BROWNS FERRY NUCLEAR PLANT (BFN) - UNITS 1, 2, AND 3 - TECHNICAL SPECIFICATIONS (TS) CHANGE 409 - ADOPTION OF TS TASK FORCE (TSTF) TRAVELER - 287, REVISION 5 - CONTROL ROOM VENTILATION SYSTEM ENVELOPE - ALLOWED OUTAGE TIME

Technical Specifications (TS) Change 409 Adoption of TSTF-287, Revision 5 Control Room Ventilation System Envelope Allowed Outage Time

Proposed Technical Specifications Changes (mark-up)

CREV System
3.7.3

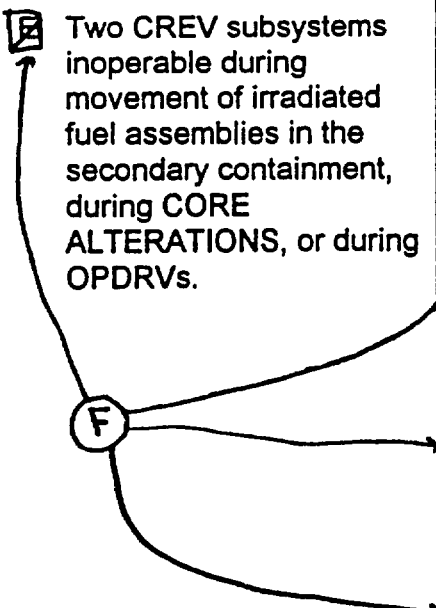
NOTE
The main control room boundary may be opened intermittently under administrative control.

B. Two CREV subsystems inoperable due to inoperable control room boundary in modes 1, 2, and 3.

B.1 Restore control room boundary to OPERABLE status.

24 hours

for reasons other than Condition B

CREV System
3.7.3

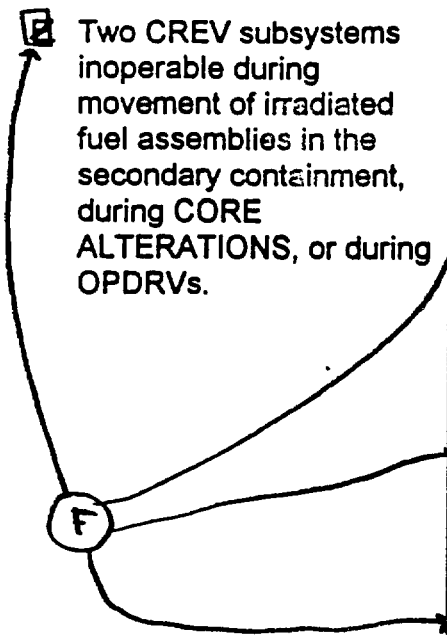
NOTE
The main control room boundary may be opened intermittently under administrative control.

B. Two CREV subsystems inoperable due to inoperable control room boundary in MODES 1, 2, and 3.

B.1 Restore control room boundary to OPERABLE status.

24 hours

for reasons other than Condition B

CREV System
3 7.3

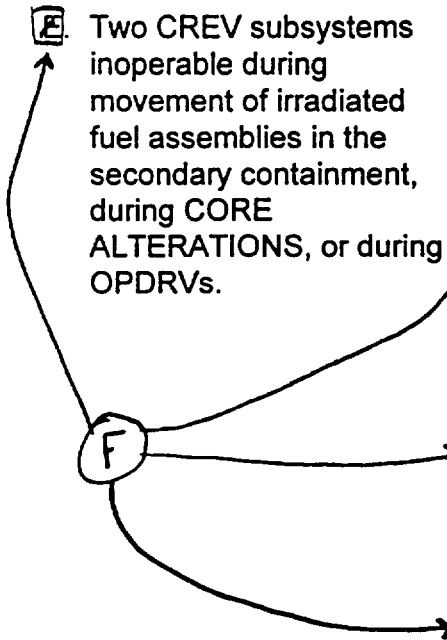
----- NOTE -----
The main control room boundary may be opened intermittently under administrative control.

B. Two CREV subsystems inoperable due to inoperable control room boundary in MODES 1, 2, and 3.

B.1 Restore control room boundary to OPERABLE status.

24 hours

for reasons other than Condition B

BASES (continued)

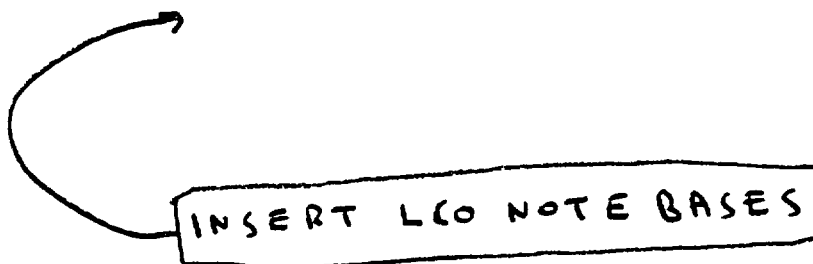
INSERT
LCO NOTE BASES (~~DWR 3.7.4, MCREC System~~)

The LCO is modified by a Note allowing the main control room boundary to be opened intermittently under administrative controls. For entry and exit through doors the administrative control of the opening is performed by the person(s) entering or exiting the area. For other openings, these controls consist of stationing a dedicated individual at the opening who is in continuous communication with the main control room. This individual will have a method to rapidly close the opening when a need for main control room isolation is indicated.

BASES (continued)

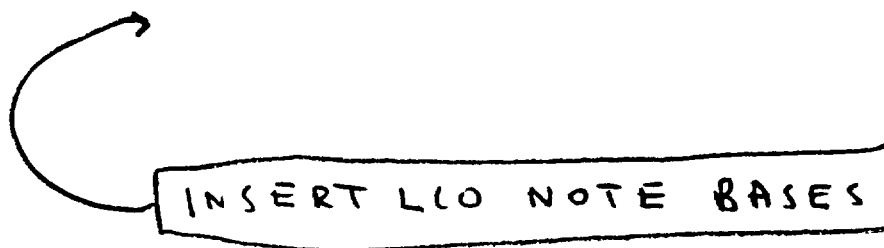
INSERT

LCO NOTE BASES (BWR 3.7.4, MCREC System)

The LCO is modified by a Note allowing the main control room boundary to be opened intermittently under administrative controls. For entry and exit through doors the administrative control of the opening is performed by the person(s) entering or exiting the area. For other openings, these controls consist of stationing a dedicated individual at the opening who is in continuous communication with the main control room. This individual will have a method to rapidly close the opening when a need for main control room isolation is indicated.
